From: sdavis@blm.gov
Sent: Thursday, July 07, 2011 5:17 PM
To: Mills, William
Subject: Fw: 36-16183 Clarifying POD Remark
Attachments: 36-16183.pdf

To
Steven R Davis/TFD/ID/BLM/DOI@BLM
cc
Fredric Price/ISO/ID/BLM/DOI@BLM
Subject
36-16183 Clarifying POD Remark

36-16183

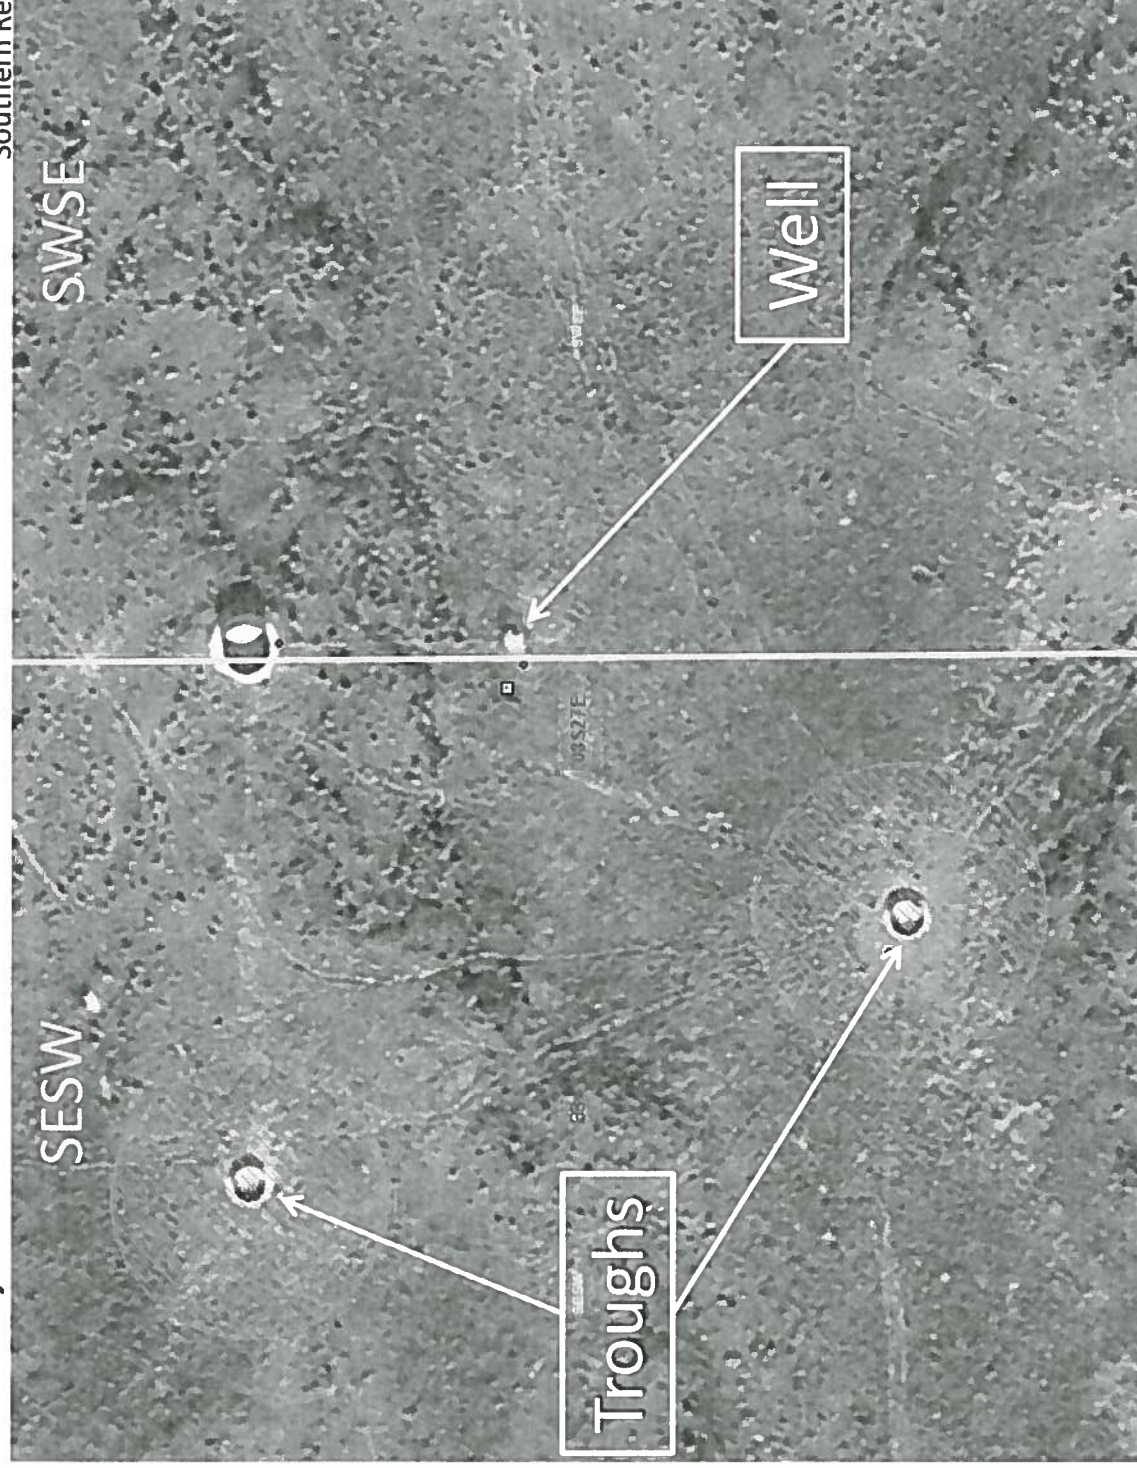
Thank you for getting back to us about this license Steve, the information was very helpful. The licensed POD location is T08S, R27E, S33, SESESW however, IDWR's gps point found the well to be 1 meter into the SWSE.

Instead of filing a petition and a license amendment to change the POD's location to the SWSWSE, perhaps we could ask IDWR to add a remark to clarify the POD's location? The Remark would read something to the effect:

"The POD lies on the line between the SWSWSE and the SESESW of S33, T08S, R27E." Attached is an image showing this. What do you think?

This is Bing Map 2010 imagery in ArcMap 10. This updated software shows the POU for the Troughs is consistent with the license. However, the well is found approximately 1 meter to the east of the coordinate line, placing it in the SWSE QQ when the license describes it in the SESW QQ. Because the well is so close to the coordinate line, and the legal description in the permit and licensing process appeared to be correct with older NAIP imagery, the BLM wishes to clarify the location of the POD (well) with the remark: "The POD lies on the line between the SESESW and the SWSWSE."
